PROPOSALS FOR A NEW MOTORWAY REST AREA ON LAND AT JUNCTION 16 OF THE M4, WILTSHIRE - RESPONSE TO WILTSHIRE COUNTY COUNCIL COMMENTS APPLICATION REF: PL/2023/09142 – OCTOBER 2024 (3728)

Eddisons have been instructed to advise on the highways and transportation issues relating to proposals for a new Motorway Rest Area (MRA), located on land at Junction 16 of the M4 in Wiltshire.

This note will set out a consideration of Wiltshire County Council's (WCC) formal consultation response dated 26th August 2024. It follows a meeting which was held with WCC to discuss the outstanding highways matters on the 13th September 2024.

3728-F04

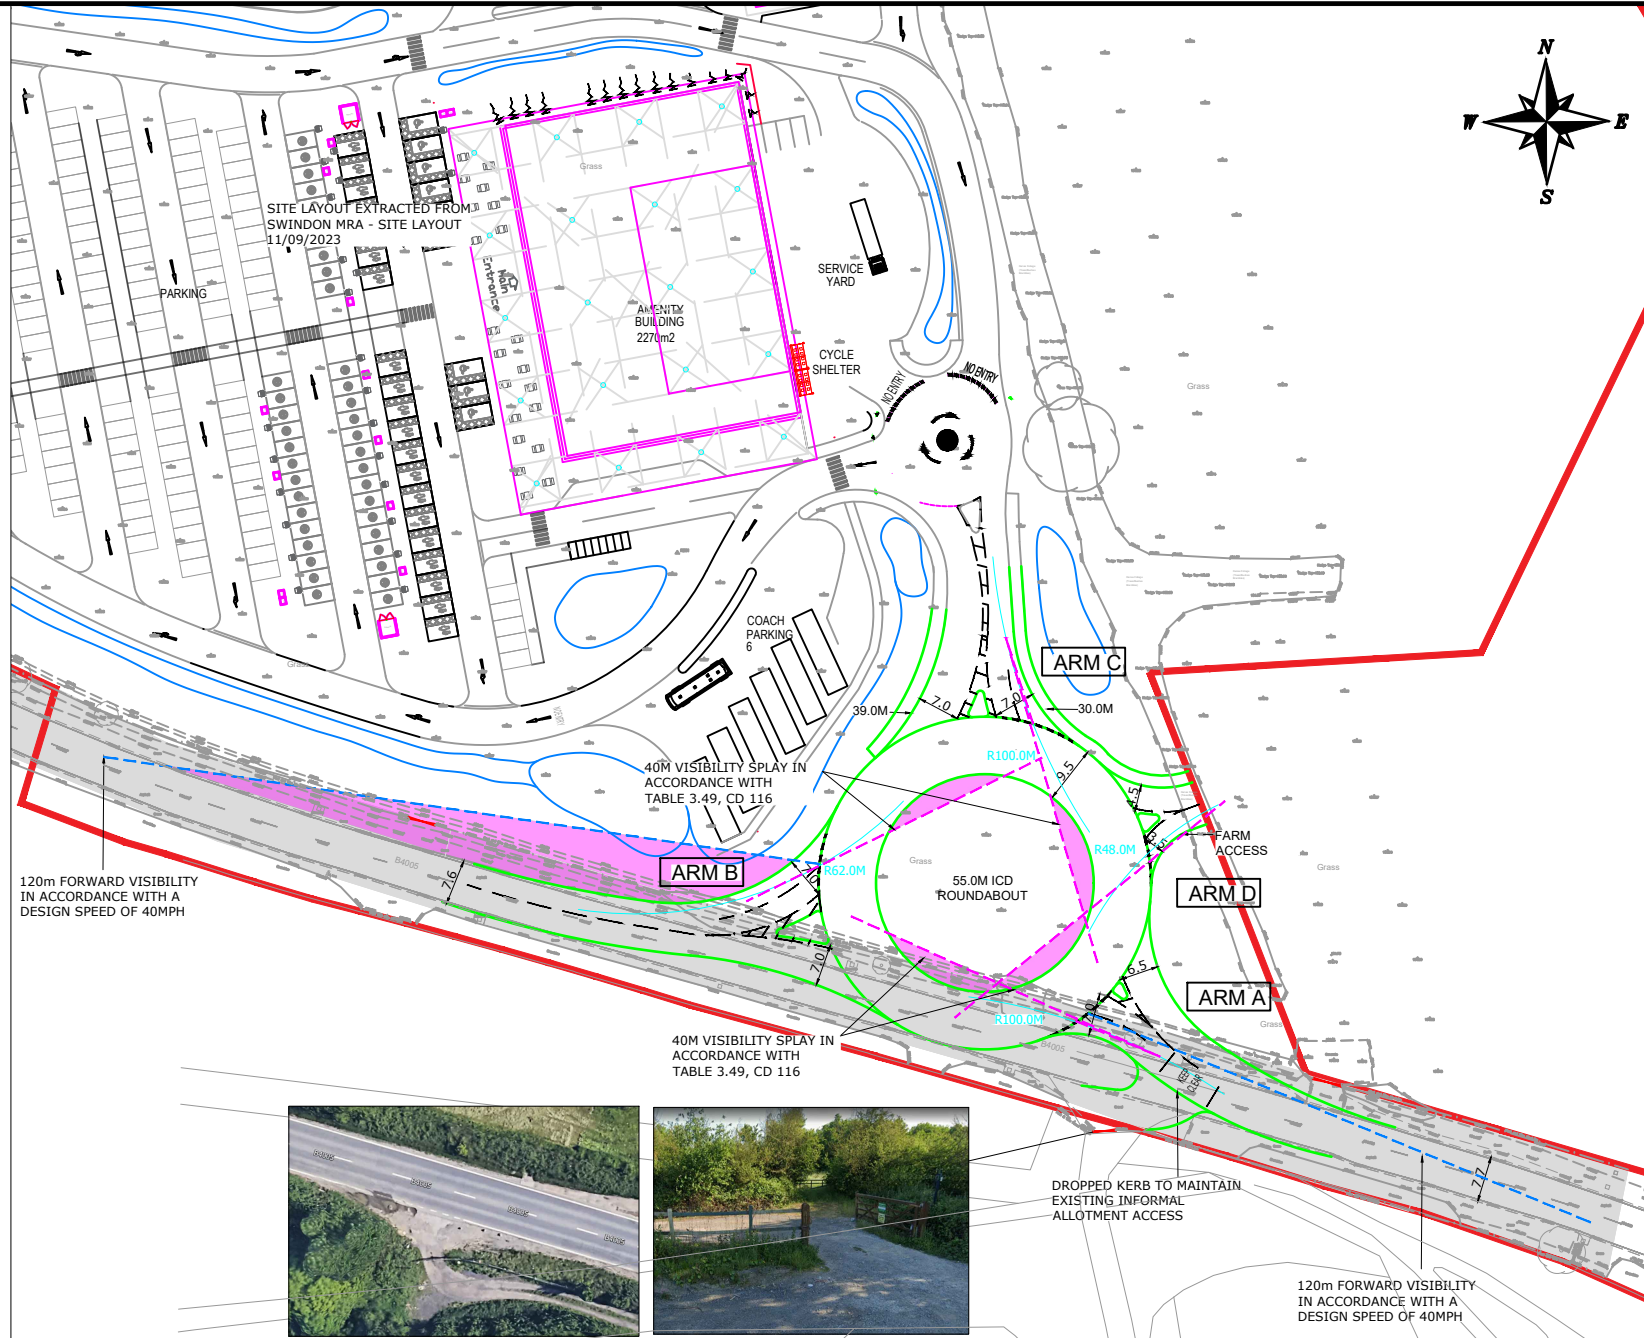
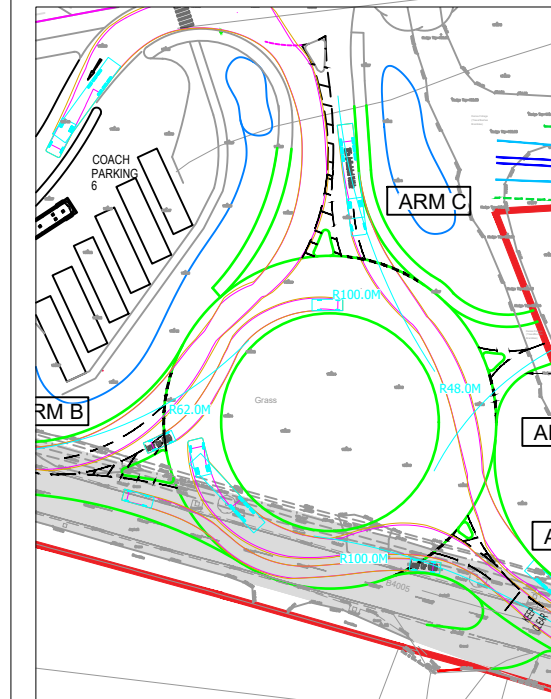
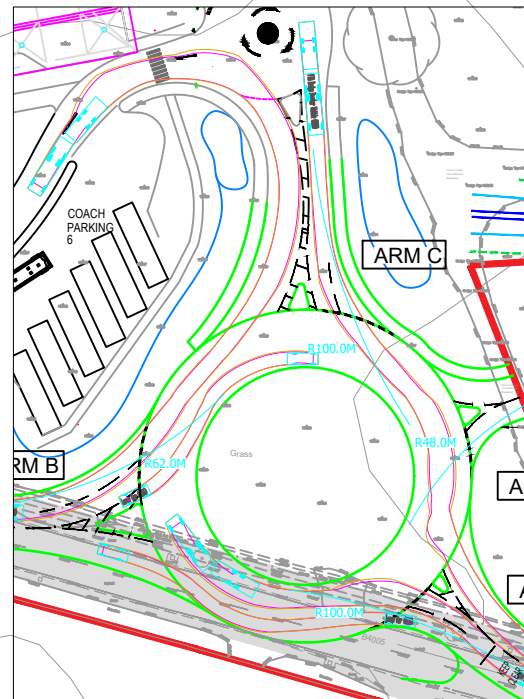
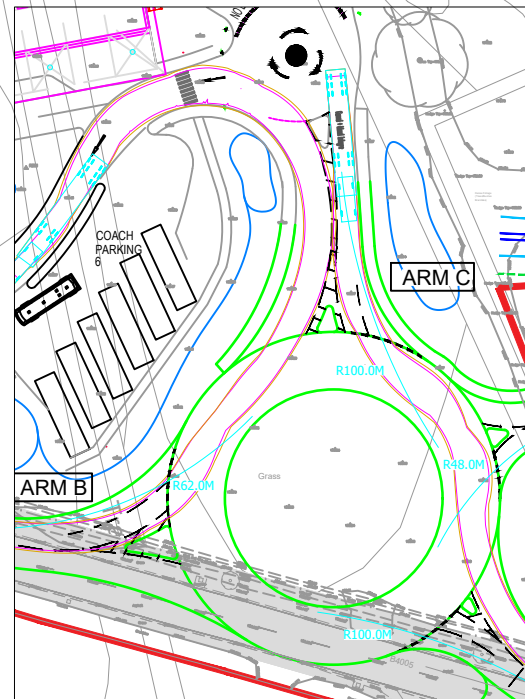
The concerns in relation to maintenance and liability extend to the proposed 55m ICD roundabout which the technical note advises is the smallest roundabout that can achieve the design standards of DMRB.

For that position to hold, if looking at the motorway junction itself and the proposed access point then the route connecting must also be, without departure to DMRB standard. The presumption being that DMRB is the de facto standard for connecting an off-line motorway services back onto the motorway.

In the absence of any rationale or optioneering to demonstrate that a smaller or simpler form of junction cannot accommodate the proposed levels of movement there is a concern in relation to accepting the 55m ICD roundabout.

junction. A signalised arrangement would also be a maintenance concern but could be a smaller form of junction. Given that the site is unlikely to require a ghost right turn in if gaps on the B4005 allow given that movements are more likely to come from the east for staff movements and not for use of the site.

The majority of the issue appears to be the farm access introduction which is reliant within the note on its own approval and therefore should not be shown or presented on the submissions aside from satisfying that its safe and suitable access is retained.

A four-arm roundabout with an ICD of 55.0 metres has been proposed, as any reduction in ICD would render the roundabout non-compliant with DMRB standards, necessitating a departure from standards and potentially introducing safety concerns related to vehicle tracking and entry path curvature.

To confirm, the fourth arm is required to maintain a farm access into the adjacent field. This farm access cannot be provided within the MRA due to National Highways Policy which prevents access into other developments through a roadside facility. It is also not considered practical to create a new farm access further along the B4005 to provide access into the field, due to level differences and the impact on the established buffer zone planting. It should be noted that the fourth arm has been designed to accommodate farm vehicles only and any change of use associated with the adjacent site would be subject to an entirely separate planning application.

To ensure compliance to the Geometric Design of Roundabouts (CD 116), the relevant geometric criteria for the proposed roundabout are listed in the table below. This table should be reviewed in conjunction with the roundabout proposals shown in plan **3728-F04 Rev I**.

Alternative access arrangements, such as a signalised junction, have been considered. The following points outline why a signalised junction would not be suitable for this location in these circumstances.

The existing area predominantly utilises roundabouts throughout the network. The proposed roundabout aligns with the character of these existing junctions.

A signalised junction would require a similar amount of land as the roundabout, as it would need to provide multiple lanes in advance of the stop lines to accommodate left-turning HGVs approaching the proposed MRA, this would increase land take alongside the requirement to provide additional widths for the signal heads. The turning lanes would necessitate the removal of the existing hedgerow for large extents of frontage adjacent to the site, impacting on hedging and greenspace on approach to the MRA. In contrast, the proposed roundabout minimises hedgerow loss and includes a green area within its central ICD which can be utilised for green landscaping.

Moreover, a signalised junction would have a greater environmental impact, requiring powered signal heads and controllers throughout the junction for its lifespan. This would result in higher energy, maintenance and operating costs compared to the roundabout. In addition, traffic would be regularly halted at any signalised arrangement, as part of the signal timings, thus increasing vehicle emissions. It is considered a free-flowing roundabout is preferable in this location to keep traffic moving along the B4005 and the roundabout has been demonstrated to operate within its theoretical capacity with minimal queueing and delay.

DRAWING NUMBER: 3728-F10 REVISION: -

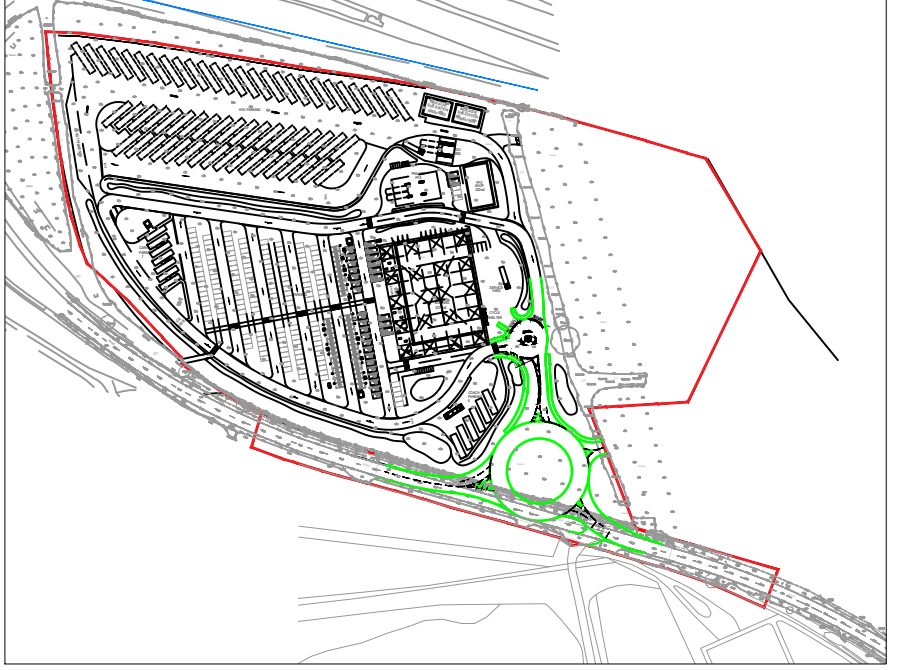
The signing is noted but should be designed sufficient to enable a Stage 1 safety audit can consider the implications of increasing sign numbers and sizes at a motorway junction and on routes leading to and from.

The increase in the number of signs is in accordance with the guidance mentioned above and the requirements for the proposed MRA. Any proposal to enlarge the existing ADS signage would necessitate minor modifications, as illustrated in plan **3728-F10**. These modifications may include adding a panel to the existing sign or incorporating a flag-type sign, as specified in the guidance.

In summary, the signage strategy in advance of the MRA is appropriate to adequately direct all traffic from the M4 to the proposed facility. The signage design has been fully considered and is suitable for inclusion as part of an RSA 1. The construction details for any new signs, improvements to existing signage and potential locations will need to be agreed at the detailed design stage with National Highways which can be subject to an appropriately worded condition. The signage will be subject to an RSA Stage 1/2, 3 and 4 to be agreed with National Highways.
